**No.: 14 TS-26**  
September 18, 2014

SUBJECT: **Replacement of the High Pressure Fuel Pump Camshaft Oil Seal**

d470302b

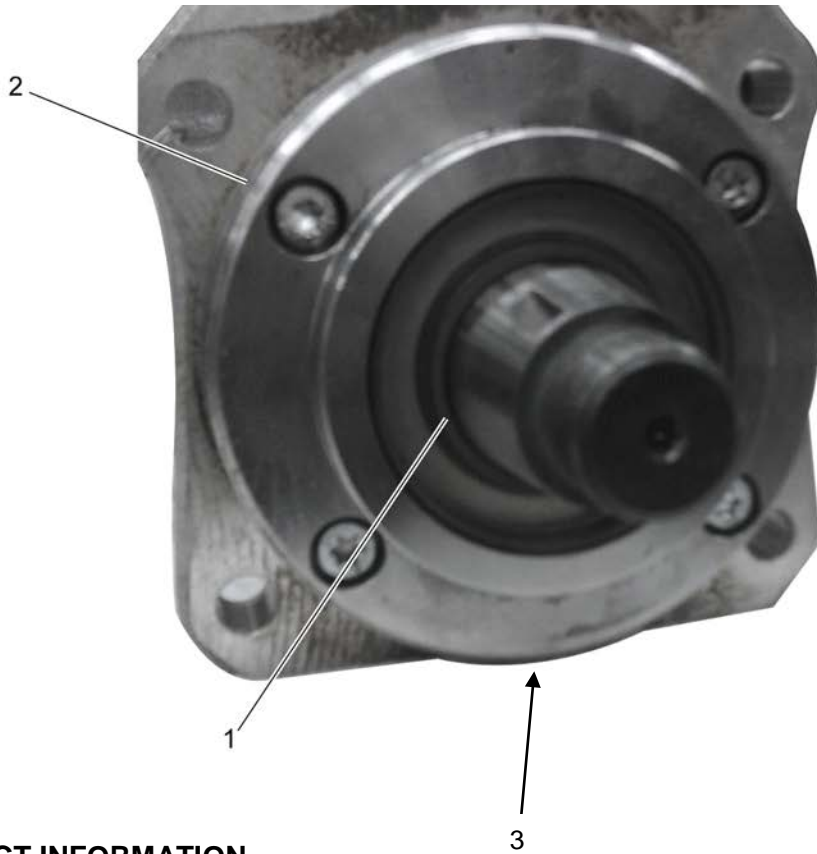
High Pressure Fuel Pump (HPFP) camshaft oil seal (1) can fail causing an oil leak at the weep hole location (3) on the HPFP. Replacement of the HPFP is no longer necessary; replace the oil seal instead. High Pressure Fuel Pumps affected are EPA07/10 and GHG14 DD13/15/16 engines, built before engine serial number 201835 with Racor three-filter and KM59 (GEN1) two-filter systems and ESN 205055 with KM63 (GEN2) two-filter system .

Do not mistake an oil leak at the HPFP for the O-ring (2) at the groove on the HPFP that seals the HP pump into the timing case. The O-ring (2) on the HPFP is serviceable on all pumps. The camshaft seal will leak at the weep hole location (3).

18SP706 and service tool W470589055900 will provide the necessary tools, parts, and instructions required to replace the HPFP camshaft seal (1).
